CONTRACT Change ORDER NO.8

DATE: 5/18/2026

PROJECT: Lake County Sheriff's Administration Renovation  
 Project No. 250816

### HP-3 Piping Reconfiguration Due to Design Revisions

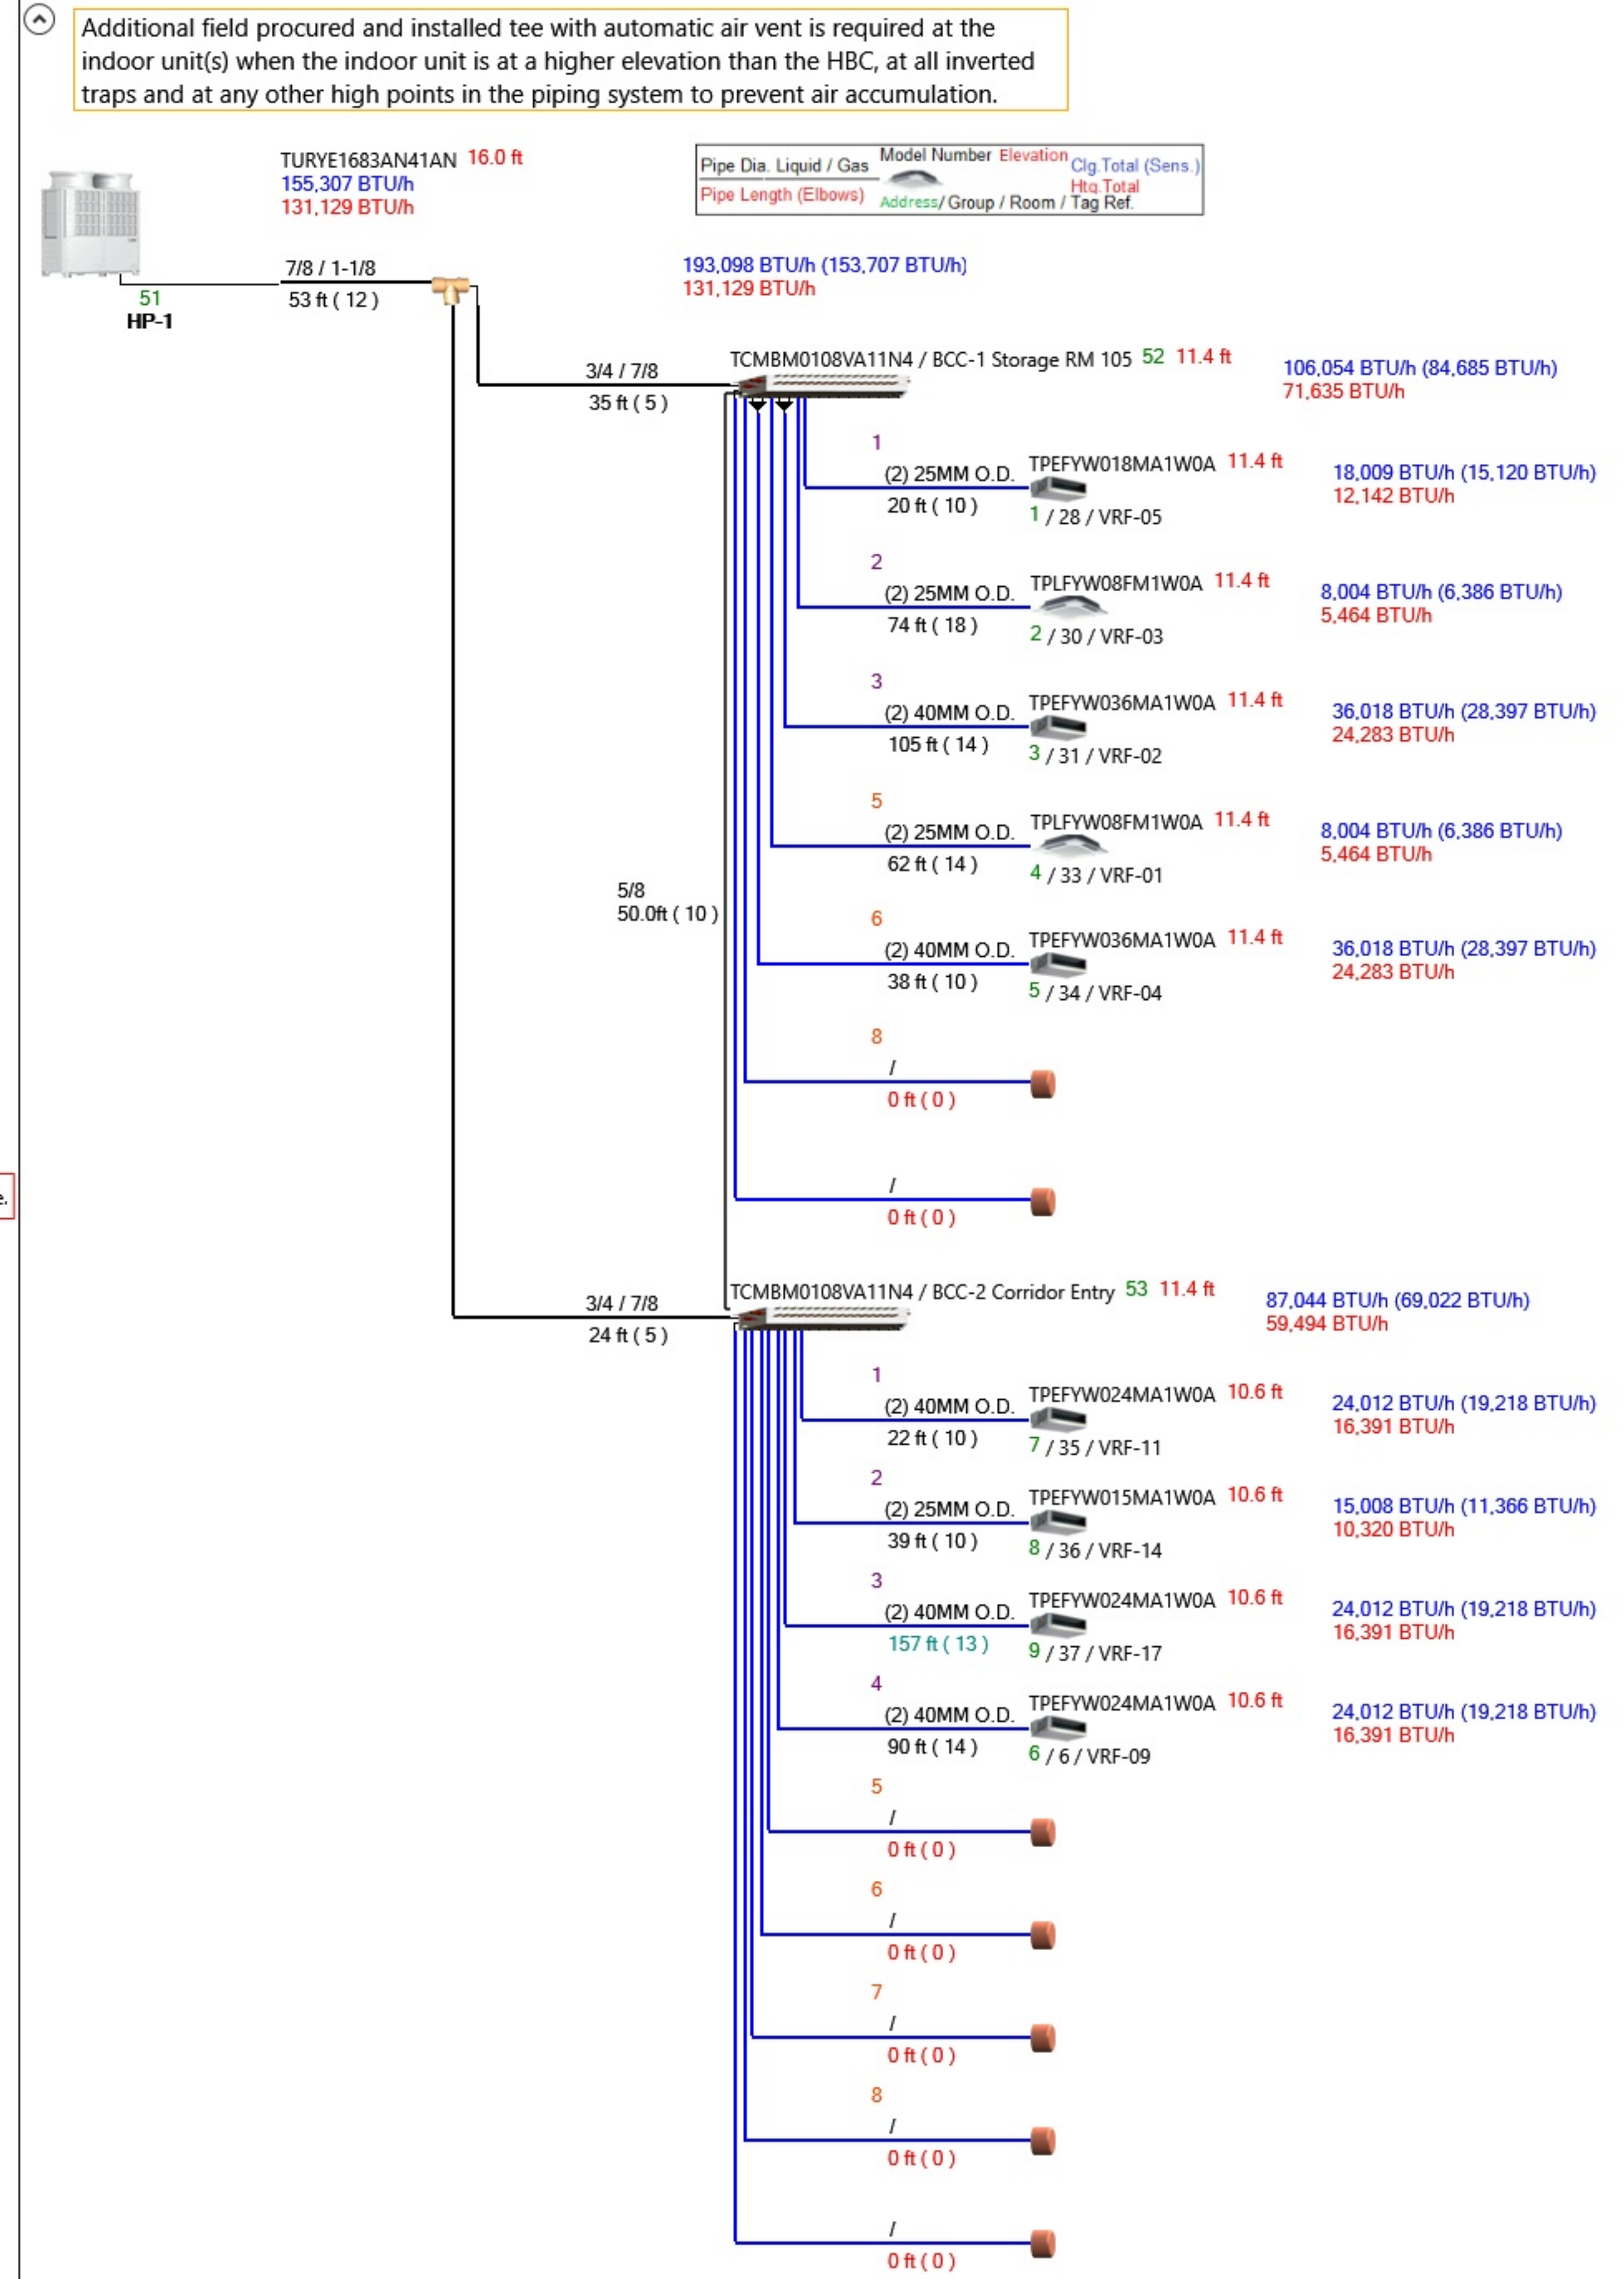
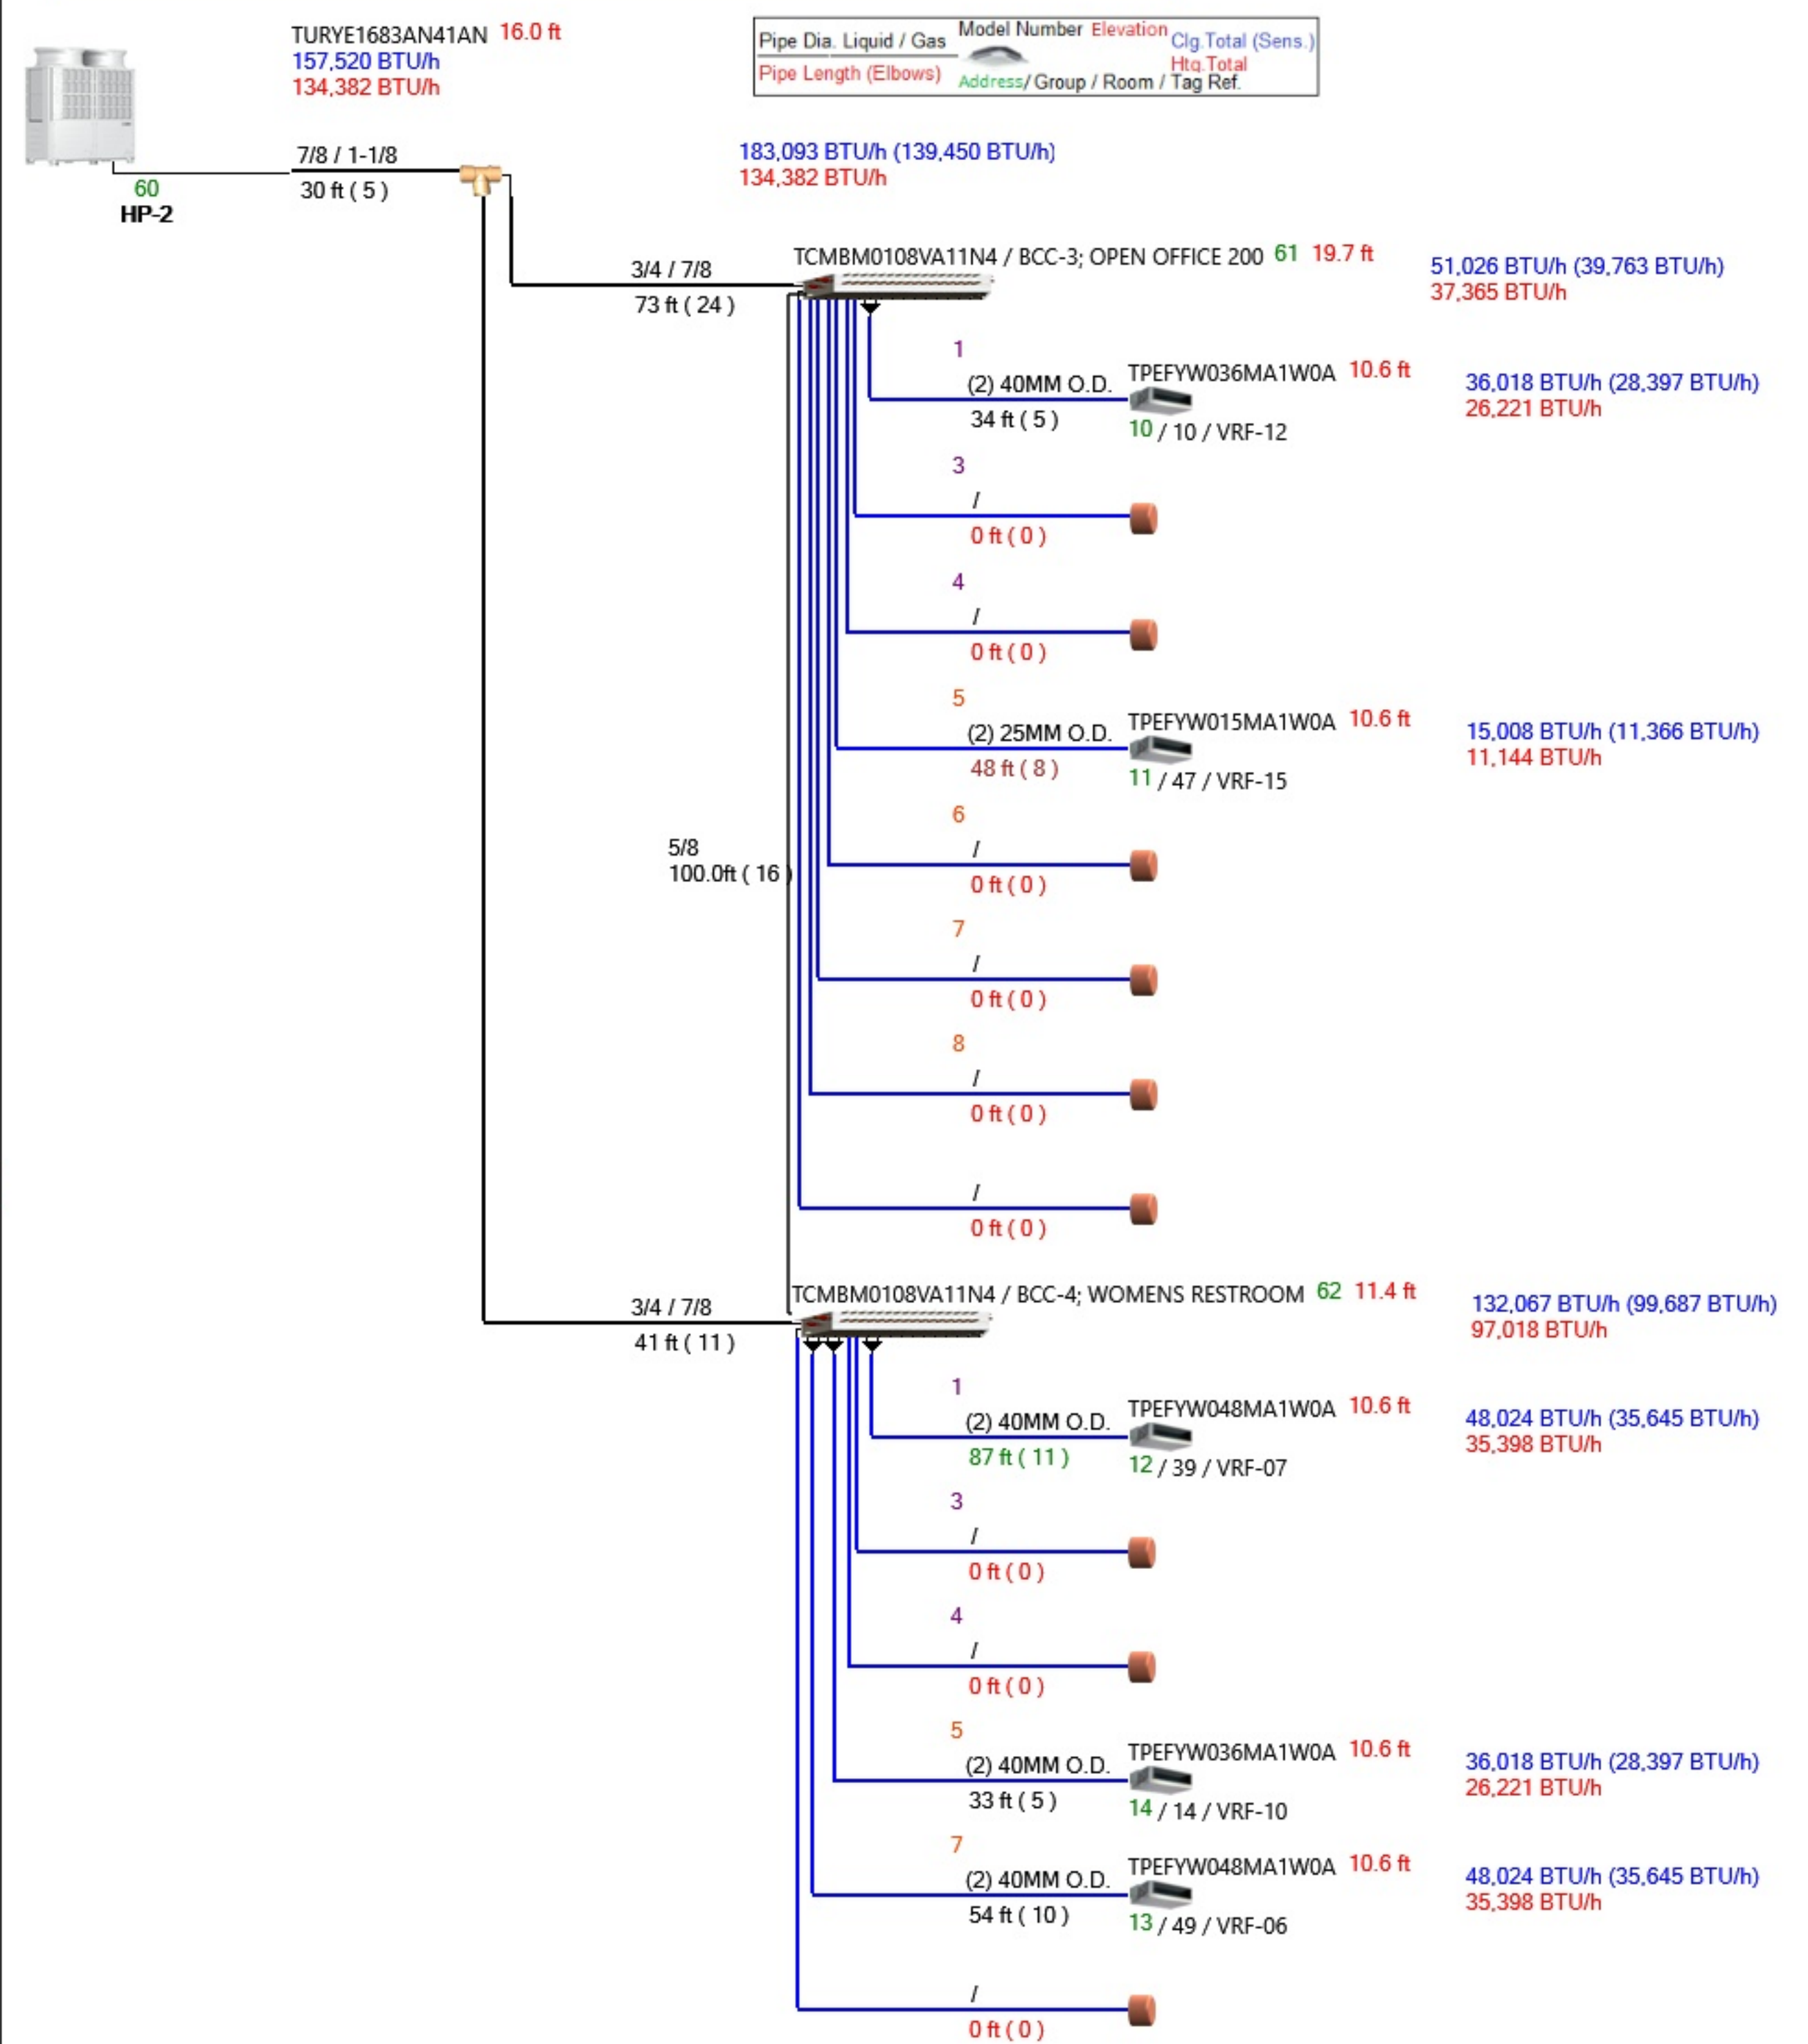
| Name                                | Type                          | Description   | TOTAL               |
|-------------------------------------|-------------------------------|---|---------------------|
| Design Revisions                    | HP-3 Piping Reconfiguration   | HP-3 is currently at maximum capacity. To ensure proper system performance and hydronic flow, piping at BC-5 and BC-6 will need to be reconfigured to accommodate the required capacity.  |                     |
| VRF-8 & VRF-13                      | Re-Port at BC-5               | Need to Twin VRF-8 to Port 1&2 at BC-5 and twin VRF-13 to Ports 5&6 at BC-5. Scope: Cut in each line and add T's and elbows and braze in to the Ports that Trane suggested. 1 T needed for each VRF and 3-4 elbows, with about 3ft +/- of copper for each VRF along with Insulation, and Insulation elbows.     | \$ 527.42           |

RFI-172 does not mention any required piping changes to VRF-16.
